DUKE POWER COMPANY  
OCONEE NUCLEAR STATION

Proposed Technical Specification Revision

Figure 3.1.2-1A

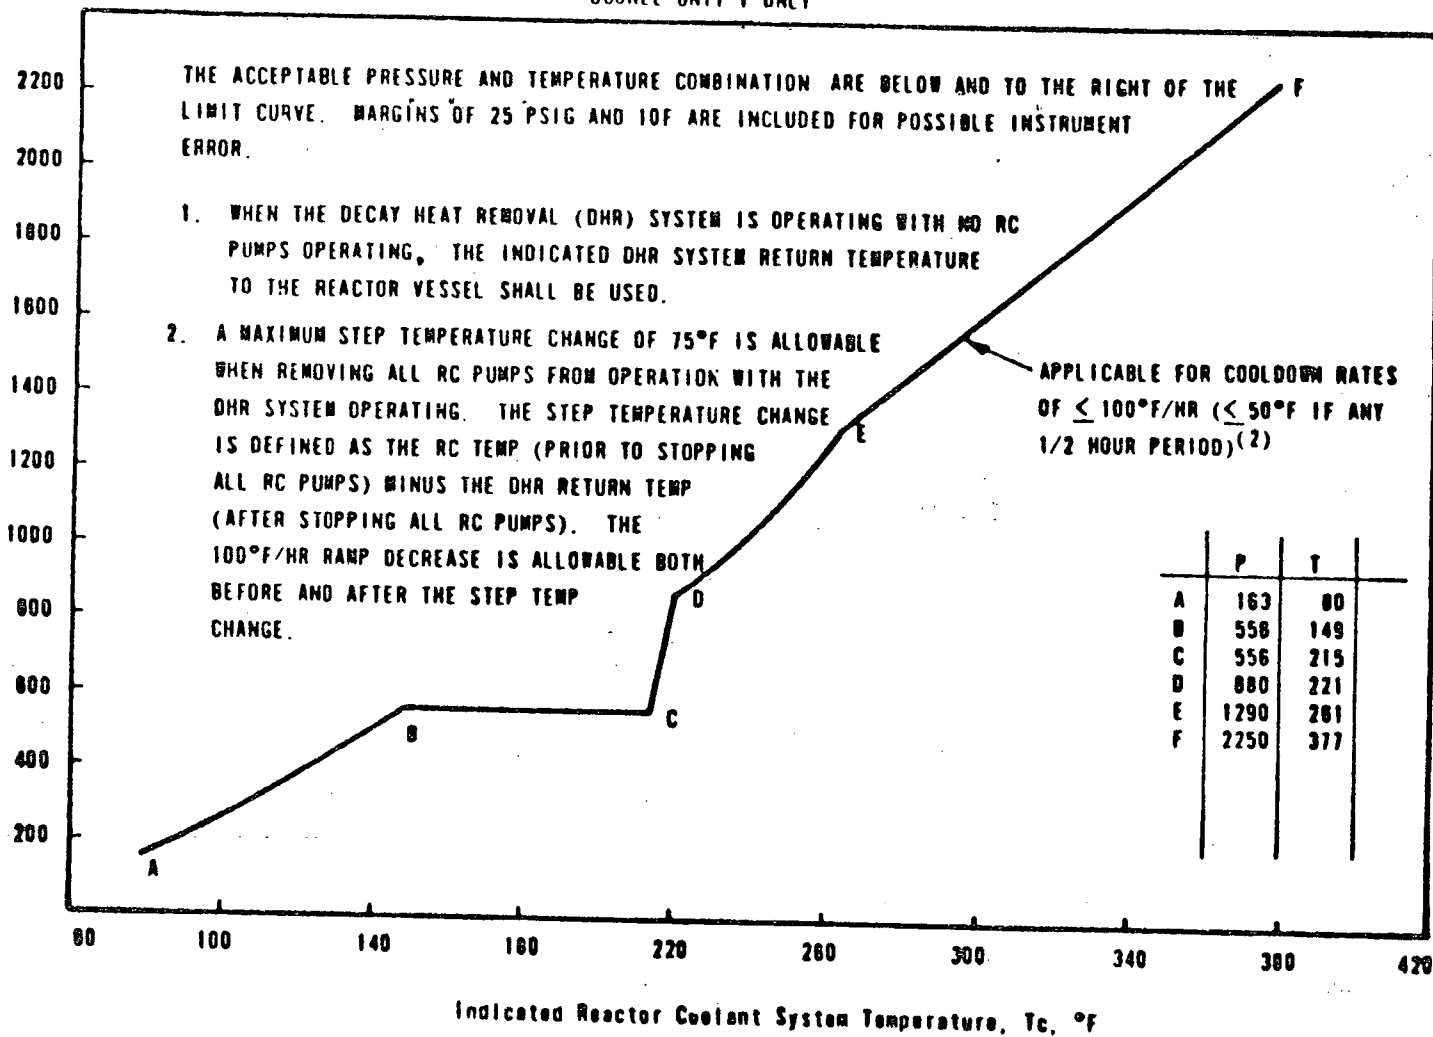
3.1.2.6 Prior to exceeding six (Unit 1)  
fifteen (Unit 2)  
fifteen (Unit 3)

effective full power years of operation.

REACTOR COOLANT SYSTEM  
 NORMAL OPERATION-HEATUP LIMITATIONS APPLICABLE FOR FIRST  
 6.0 EFFECTIVE FULL POWER  
 YEARS
